**State of Montana's Response to Design Review Team Comments on the
Clark Fork River Operable Unit Phase 7 Preliminary Design and
Design Criteria Memo**

**Presented at the Design Review Team Meeting
April 29, 2024
Deer Lodge, MT**

**Prepared by the Department of Environmental Quality and
the Montana Natural Resource Damage Program**

August 2024

Figure A. Preliminary Phase 7 aquatic habitat features. Mapped on high-resolution UAV imagery acquired on July 12th, 2023, when flows at USGS gage 12323800 near Galen were 250cfs.

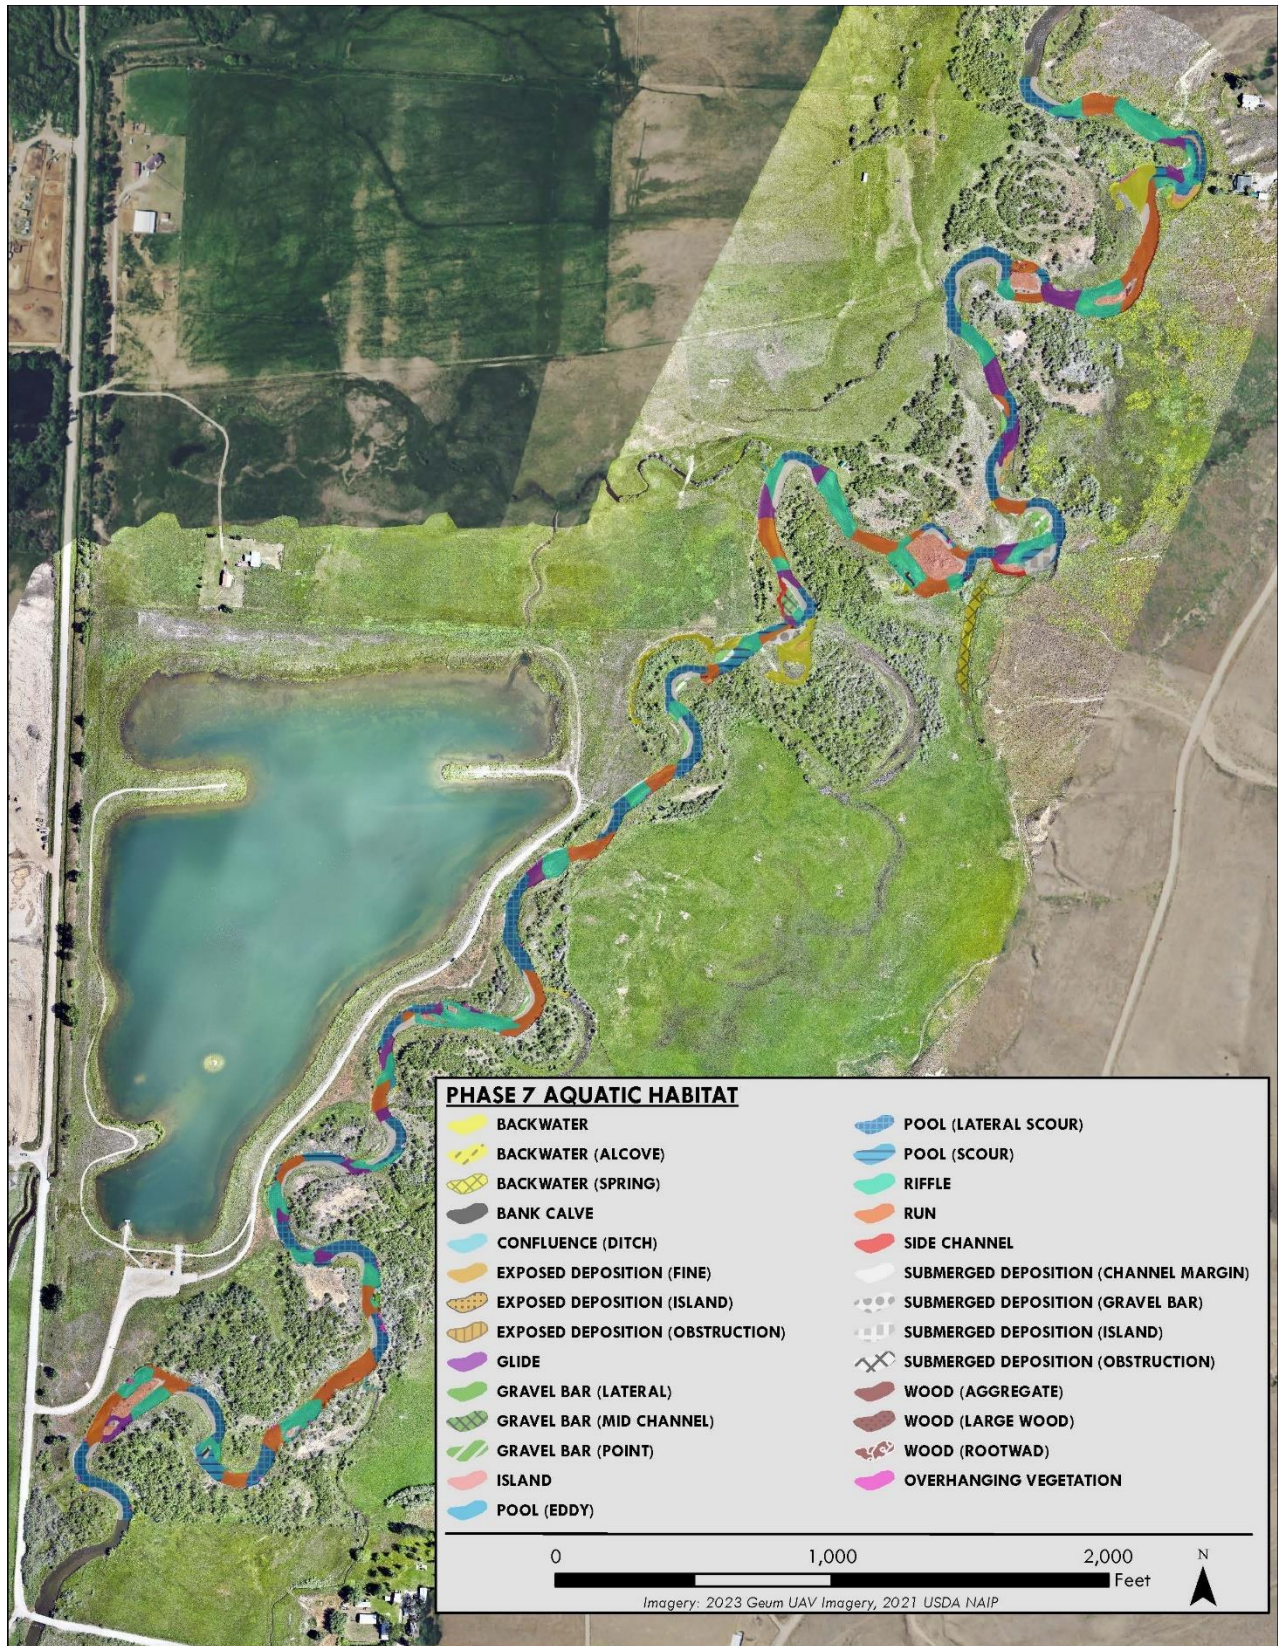
- 3. I understand the current restoration effort is to work within the existing planform for the river. That leads to a couple questions:**
 - **I did not see any reference to bed modification – for example construction of pool-glide-riffle sequences. I do not have the eyes-on experience of yourselves or the design team, but recall poor instream habitat through much of the Deerlodge section – for example graded through pools on outside meander bends. Longer-term vegetation may promote bedform diversity, but it will take time, and possibly some hydrologic events.**

Response: The selected remedy for the CFROU (see the ROD section 13) does not include remediation of the streambed and in-stream work ranked low in NRDP's Clark Fork River Aquatic habitat and Riparian Restorations Actions and Prioritization Analysis (please see <https://dojmt.gov/wp-content/uploads/CFR-Aquatic-Riparian-Restoration-Prioritization-2019.pdf>). The proposed remediation work in Phase 7 is limited to outside the existing streambanks. Figure A is a preliminary map of in-stream aquatic habitat in Phase 7.

Figure 1. Clark Fork River channel migration zone map prepared by Applied Geomorphology, Inc.

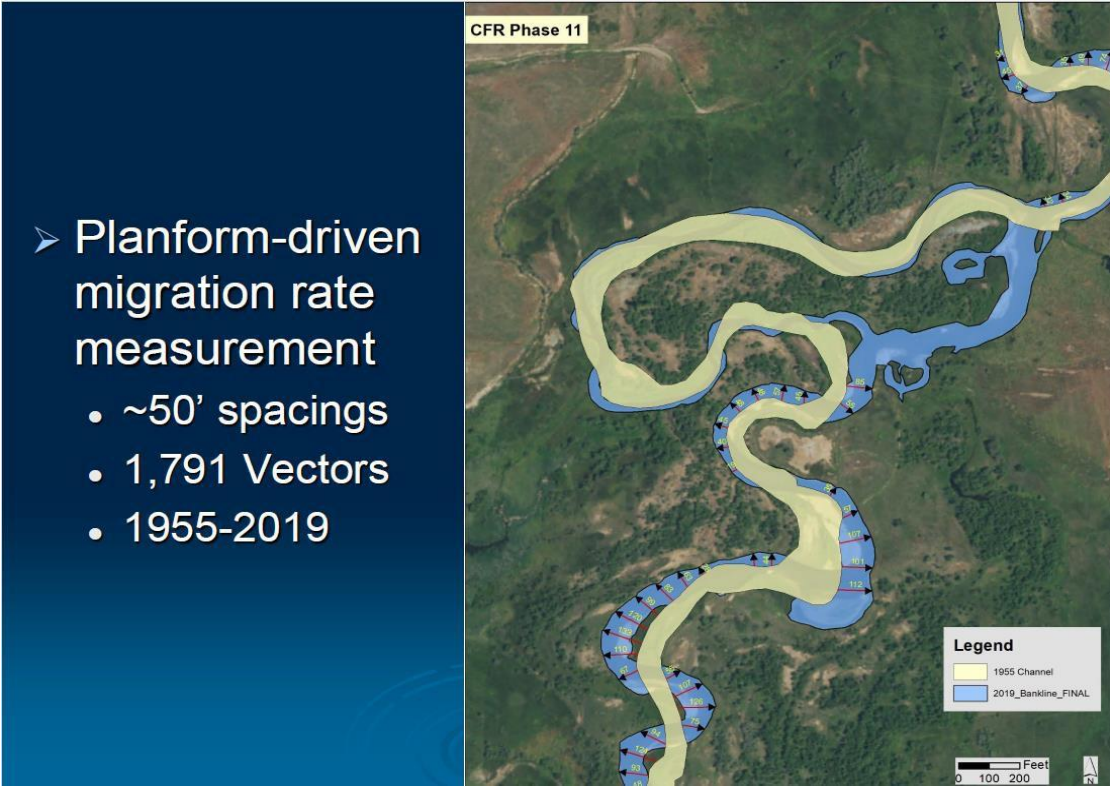
Comment 1: The use of CMZ mapping is a great tool for planning remediation and restoration activities near the river channel. The current methodology creates vectors for channel migration measured over 64 years of aerial imagery, then projects those vectors out over a span of 100 years and averages the lengths of all vectors to derive an average 100-year channel migration zone. The average 100-year migration zone is applied uniformly to Phase 7 and adjusted to improve constructability and tailings removal. This approach to CMZ mapping may be appropriate for managing an uncontaminated floodplain but may not be appropriate for the CFROU.

Response: The agencies and design team appreciate alternate ideas to the application of the CMZ as the base remedy for the CFROU. The Strategic Plan indicates that removal extents and designs for each Phase will “be based on a common base remedy defined by the CMZ and additional remediation actions guided by the results of design-level investigations”. The agencies

Figure D. STA 66+50 to 81+50 Velocity maps for Q1.5 Existing (top) and Design (bottom)

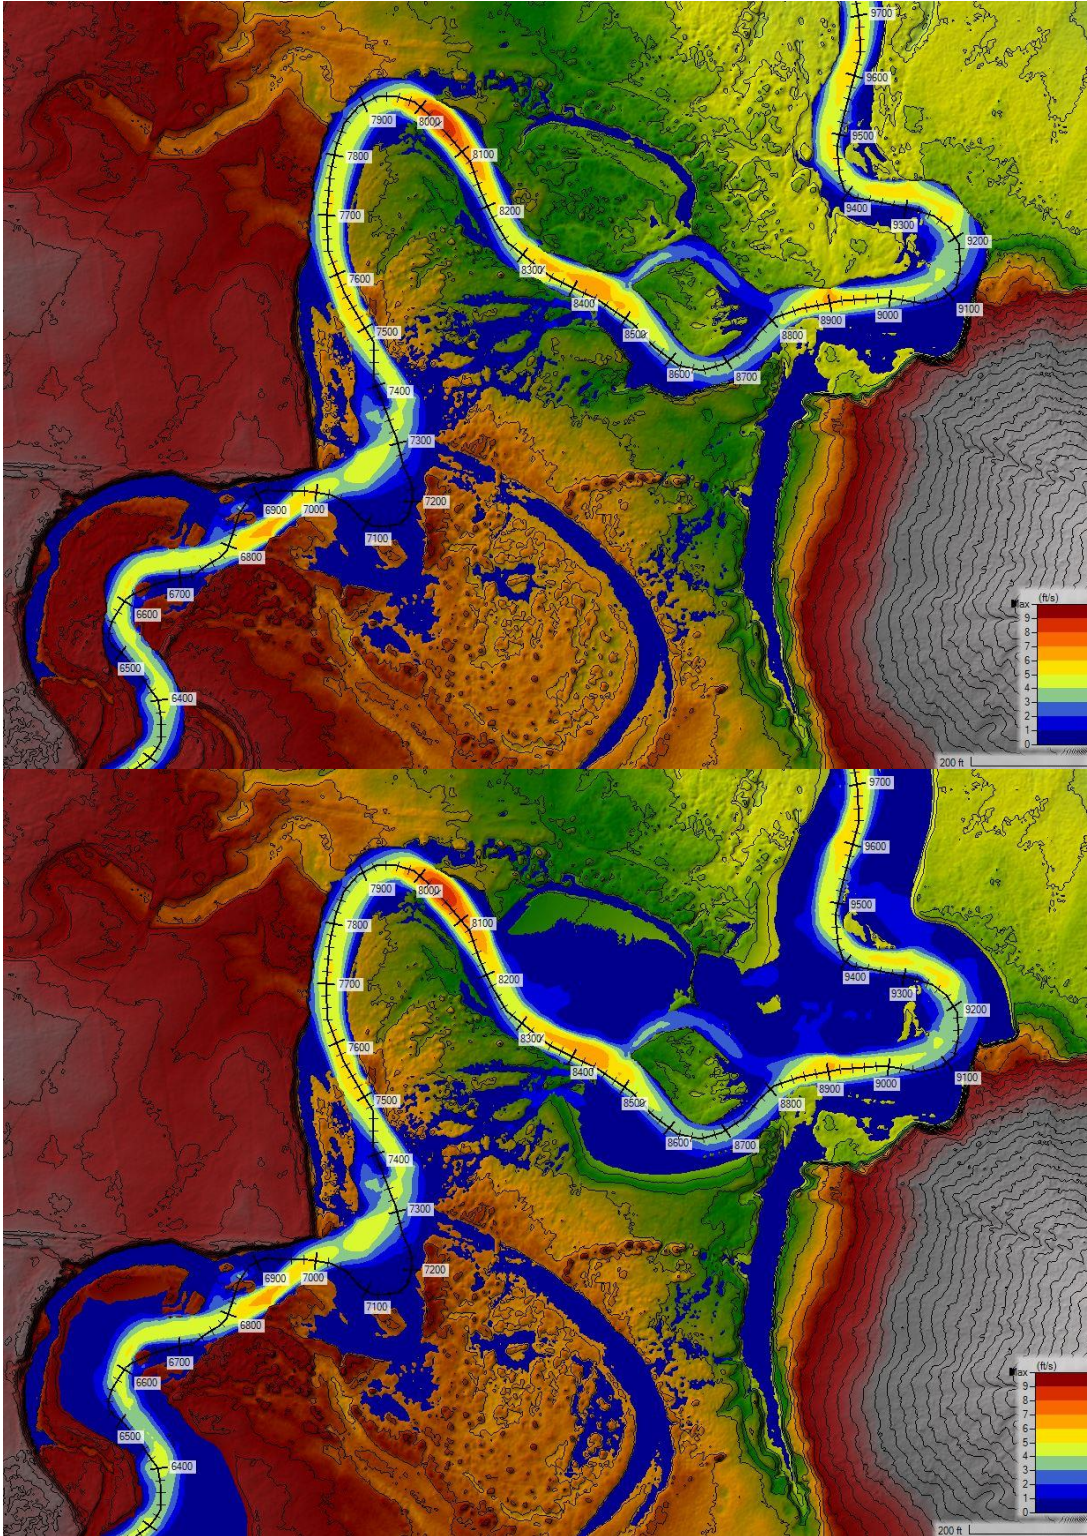
Comment 3: Additionally, the Strategic Plan states VP areas cannot occur near the channel on both sides of the river. VP areas occur on both sides of the river in several places in the current plans (see stations 66+50-81+50).

Response: Please see above response, additionally, the hydraulic modeling for Q1.5 and Q10 in the reach from station 66+50 to 81+50 (Figure D) does not seem to indicate the project will have a negative effect (increased erosion potential) in this reach with respect to the existing conditions for the two flows analyzed.

Figure F. Shear Stress profiles along CFR channel centerline for Q1.5.

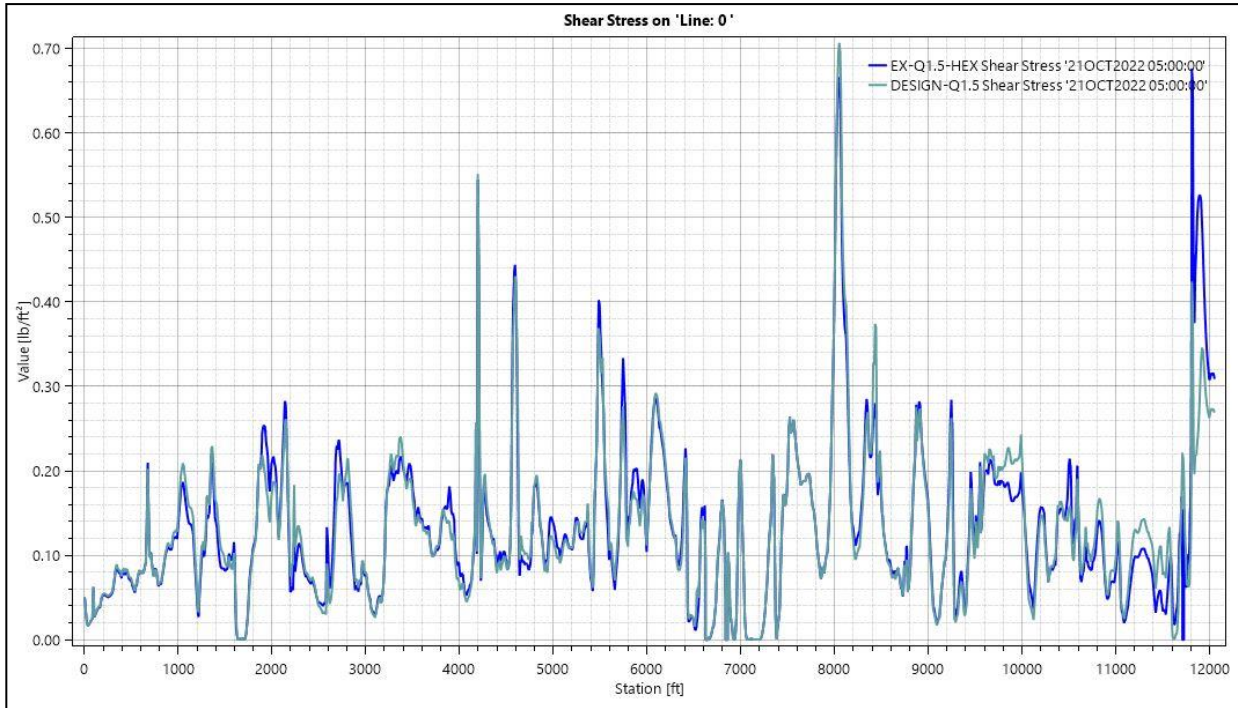
Comment 8: The DCR indicates the entire CMZ will be inundated between 0.1 and 0.5 feet at the Q1.5 discharge, which suggests flooding will begin to occur at discharges below the 1.5-year flood interval. We understand and agree with the design team's intent to encourage riparian vegetation establishment by allowing water to access the floodplain more frequently and acknowledge the TAC previously recommended lowering the floodplain following documentation of riparian vegetation establishment in earlier phases. We encourage the design team to investigate whether lowering the floodplain to an elevation at or below the 1.5-year flood has consequences on channel-forming processes. We are concerned the emphasis on vegetation establishment may come at the cost of sediment transport and aquatic habitat development and maintenance due to the reduced in-channel energy resulting from frequent overbank flooding.

The first analysis was a comparison of shear stress values (pounds per square foot) for the existing and design conditions. This analysis is primarily focused on the channel, since many areas outside the channel (on the floodplain) are not inundated at flows analyzed in the existing conditions, and thus any value in the design indicates a change. Shear stress is an often-used surrogate for sediment transport capacity of open channel flow. The 2D model results are plotted along the centerline alignment from the design plans. These profiles indicate there is very little

overall change in the shear stress values in the CFR channel. Some discrete areas indicate an increase in shear stress and appear to be associated with straighter channel reaches. Other areas indicate a decrease in shear stress and appear to largely be associated with areas of lowered inside meander bends and/or intentional areas of split flow channels in the design. For both flows analyzed, the vast majority of the project area indicates a near zero change in shear stress.

Figure J. Mobile Particle size map based on Sheild's equation and Q10 hydraulic results used to design scour resistant floodplain materials.

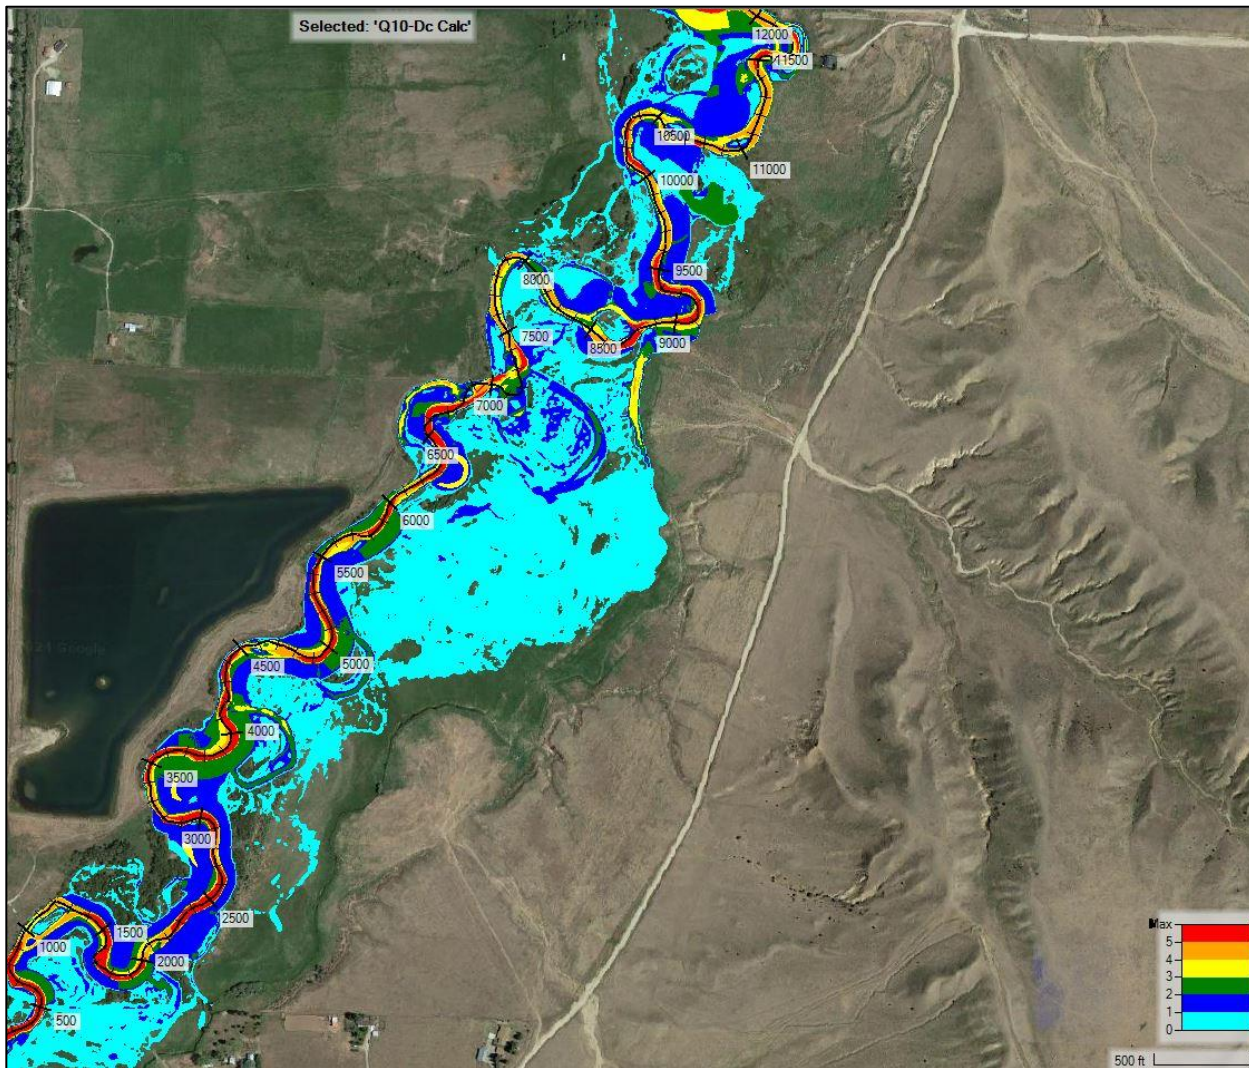
2. Whether avulsions are more likely due to the reduced sediment competency resulting from a lower floodplain elevation,

Response: Other than the split flow channel described above, no areas in Phase 7 appear to present increased avulsion potential compared to existing conditions. Avulsion potential is also

reduced through the inclusion of surface roughening, appropriately sized floodplain alluvium, and revegetation plans.

Figure K. Sediment Transport Capacity difference (existing minus design) maps for Q1.5, red indicates scour and blue indicates deposition potentials.

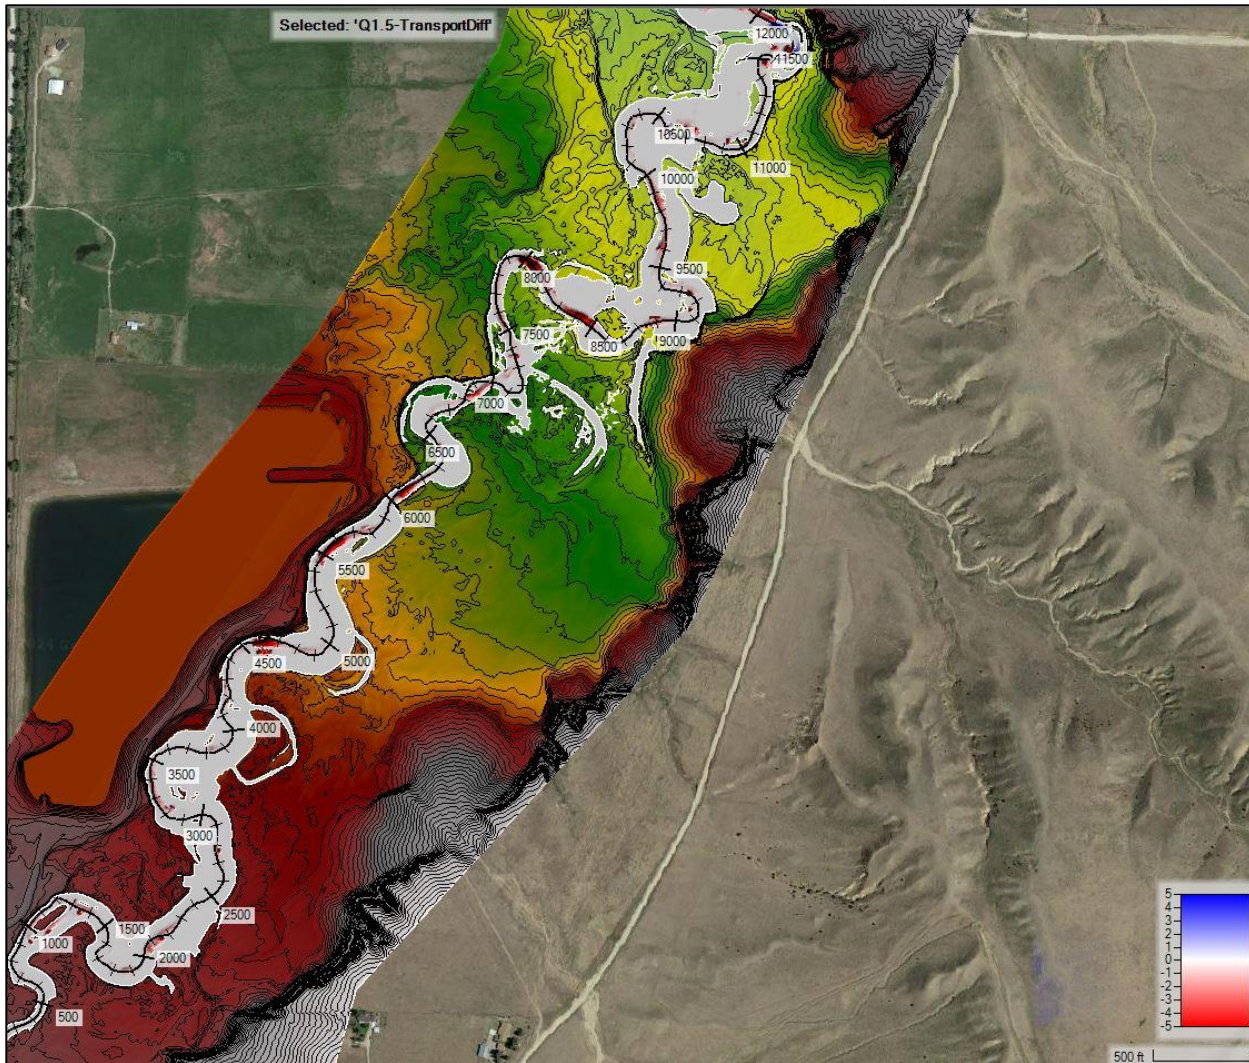
- 3. Whether sediment competency of the channel during bankfull events is sufficient to adequately scour bedform features such as pools and runs. Our concern here is partially based on DEQ's suggestion during the May 1st Design Team Meeting that the channel bed in Phase 7 has potentially become armored over time due to the lack of fine sediment delivery stemming from construction of Warm Springs Ponds.**

The sediment transport capacity comparison analysis described above indicated that changes to the locations and patterns of scour/deposition and related features are likely to occur. The results also do not indicate a global shift towards deposition and may increase the CFR channel's ability to form and maintain scour pools and runs in some areas.
